RE: OBJECTION TO DA2025/0536 – 19 BURNE AVENUE, DEE WHY

**CONSTRUCTION OF A SECONDARY DWELLING AND
ALTERATIONS & ADDITIONS TO A DWELLING HOUSE**

Figure 1: Extract from Survey of 19 Burne Avenue (Lot 2) submitted with DA, dated 29/11/21, prepared by Hill and Blume Consulting Surveyors

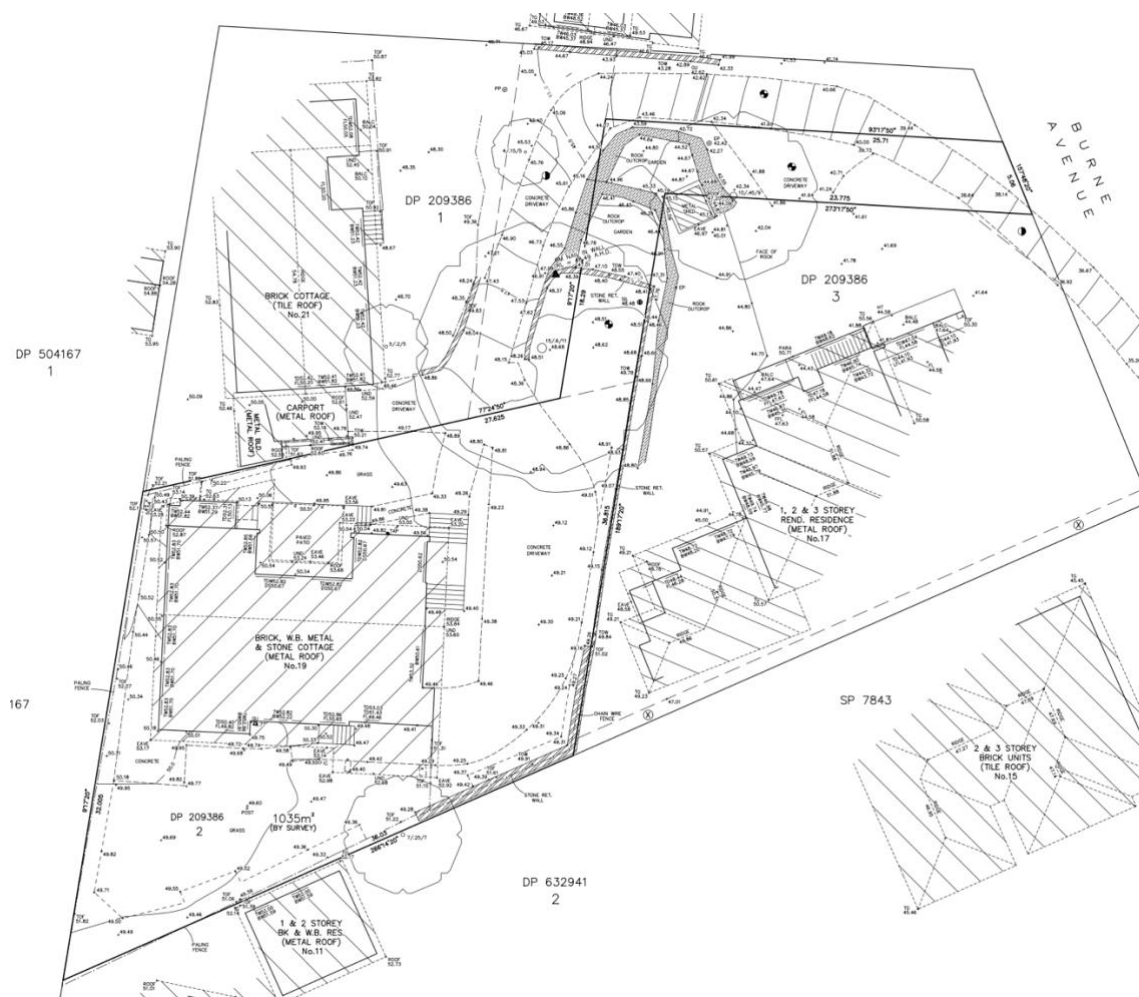
Vehicular and pedestrian access to the subject site is via an existing driveway which extends from Burne Avenue and traverses part of 17 Burne Avenue, the access handle of 19 Burne Avenue and the access handle and the main part of 21 Burne Avenue, as depicted below:

The survey identifies the existing Rights of Carriageway that apply to 17, 19 and 21 Burne Avenue. In relation to 19 Burne Avenue, the site benefits from Rights of Carriageway over 17 and 21 Burne Avenue which allow legal access to the main part of the site. Conversely, the access handle of 19 Burne Avenue is burdened with Rights of Carriageway that benefit 17 and 21 Burne Avenue.

Figure 2: Extract from DP209386, showing the R.O.W. in the access handle of Lot 2

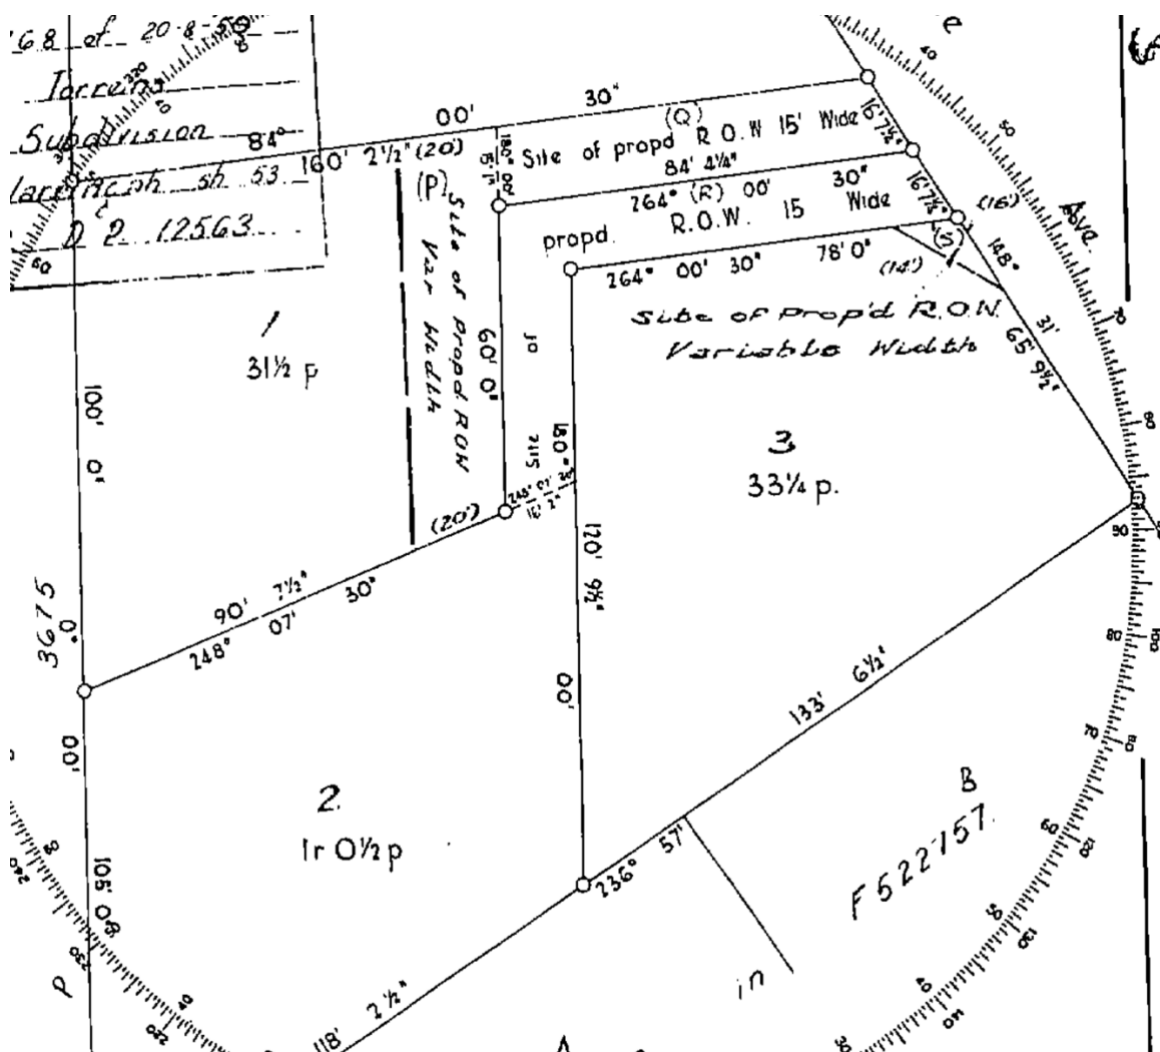
A significant and likely fatal issue with the proposed development is that the secondary dwelling is located on the access handle of 19 Burne Avenue, which would unlawfully interfere with the right to access this part of the site in accordance with the existing Right of Carriageway burdening Lot 2 and benefitting Lots 1 and 3. Any structure on the Right of Carriageway that would impede access to the Right of Carriageway by Lots 1 and 3 would be unlawful and contrary to the rights of the dominant tenement, in this case being Lots 1 and 3.

Figure 3: Photographs of Tree 3, located on 21 Burne Avenue, Dee Why

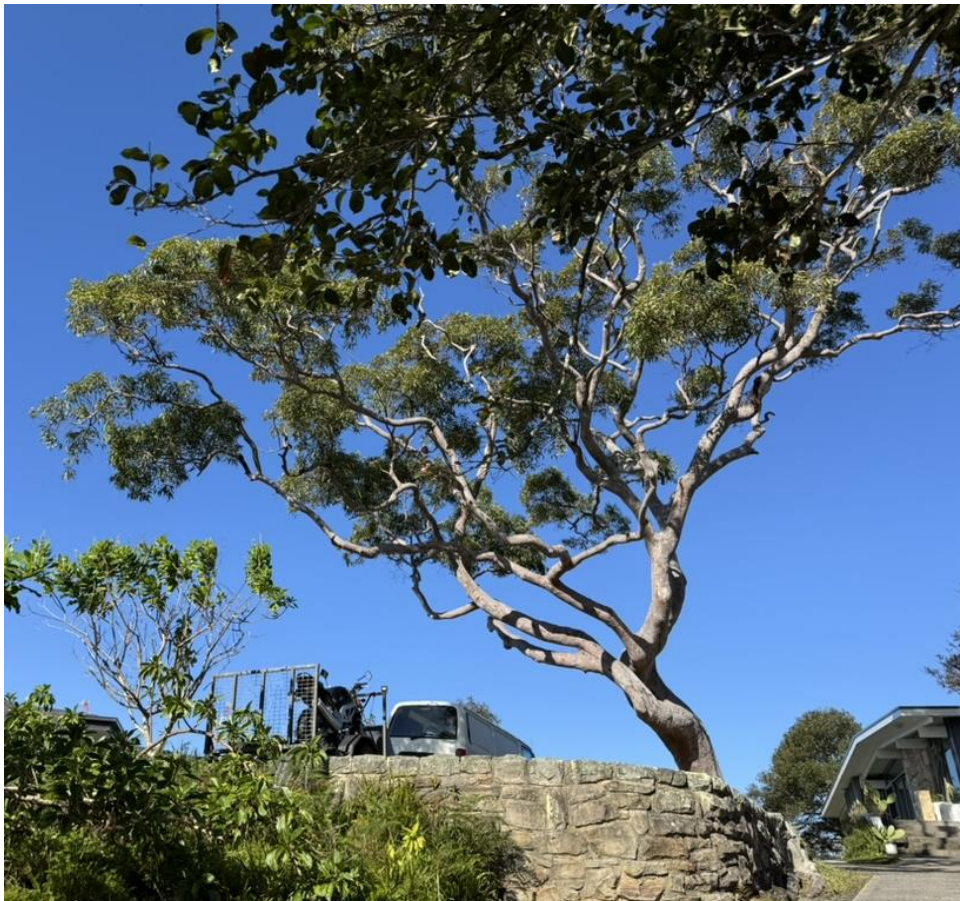
In the absence of owners' consent from 21 Burne Street, Dee Why to the development application (being land to which the development application relates in terms of the removal of Tree 3 on 21 Burne Street), the development application has not been properly made. As owners consent is a precondition to the exercise of the power to grant development consent (including deferred commencement consent), a consent authority cannot grant consent to the proposed development, due to the absence of owners' consent.

In addition to the lack of owners' consent as discussed above, the subject tree is an outstanding specimen in excellent health, contributing significantly to the amenity of the area, and regardless of whether owners' consent is obtained, should not be removed to accommodate an inappropriate and poorly sited development.

Figure 7: Extract from plan DA-14, prepared by Romina Rojo Studio, showing the western façade of the proposed secondary dwelling

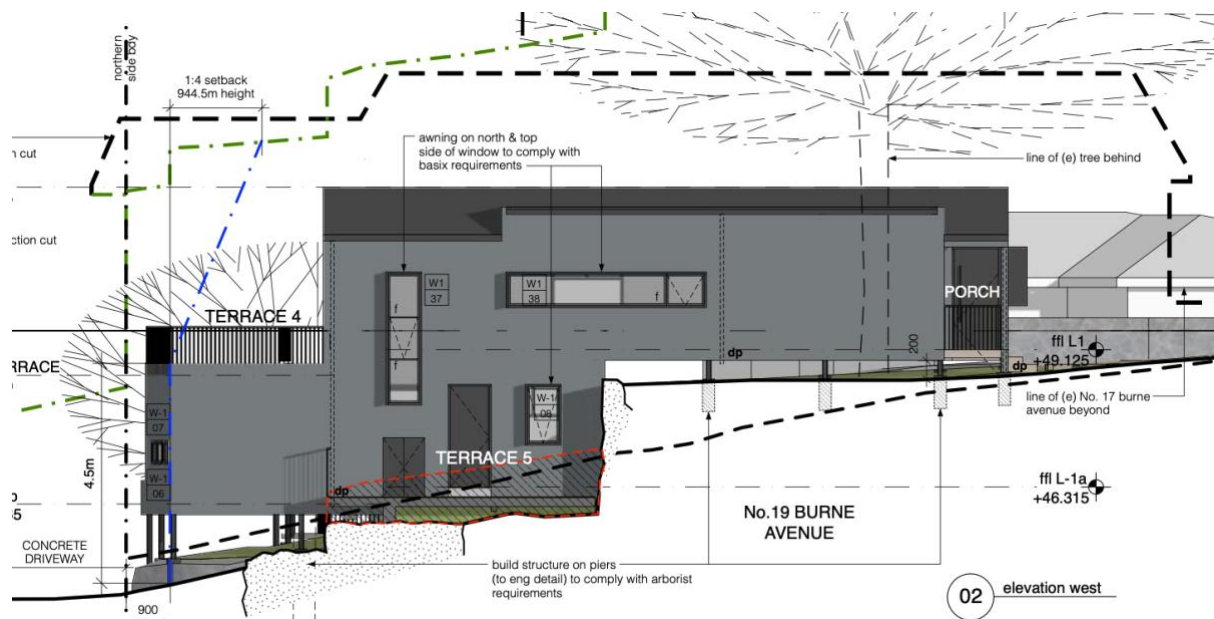
In relation to visual impact, the 14m long roof ridge of the proposed secondary dwelling (at RL52.45) would extend well above the ocean and headland horizon line currently visible from 21 Burne Avenue, and the western façade of the secondary dwelling would completely dominate the outlook from the east facing windows and balcony of 21 Burne Avenue, replacing views of mature trees and landscaping, the Dee Why town centre and the ocean beyond, with a largely blank façade, being part one and part two storeys in height, and an outdoor terrace (Terrace 4) which serves as the principal private open space of the secondary dwelling:

In relation to 21 Burne Avenue, the secondary dwelling west facing windows and Terrace 4 would directly overlook the principal private open space, balcony and living areas of the dwelling, as can be seen in the west elevation in Figure 7 above.

Figure 8: Extract from plan DA-16, prepared by Romina Rojo Studio, showing the northern façade of the proposed secondary dwelling and in the background the proposed garage and Terraces 2 & 3 above (in relation to the main dwelling alterations and additions)

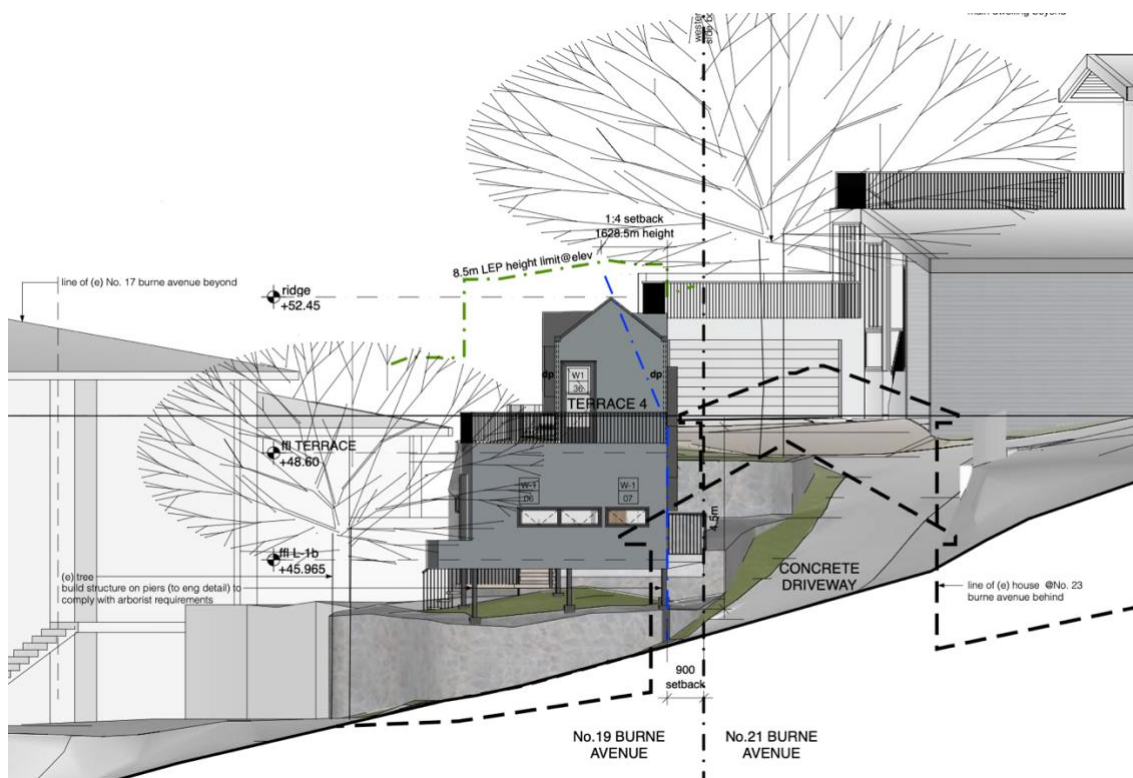
Additional overlooking impacts occur from Terrace 2 above the proposed garage, which is elevated by one storey, with an open balustrade to the eastern edge of the terrace, as can be seen on the east elevation (plan DA-08) and in the 3D rendering in Figure 9 below. The elevated nature of Terrace 2, together with the large area of the terrace (approximately 40m²) which adjoins a games room and the siting of the terrace directly opposite 17 Burne Avenue is likely to result in noise nuisance and disturbance

With regard to the above, Terrace 2 should be deleted or substantially reduced in area, with a significantly greater eastern boundary setback, in order to maintain aural and visual privacy to 17 Burne Avenue.
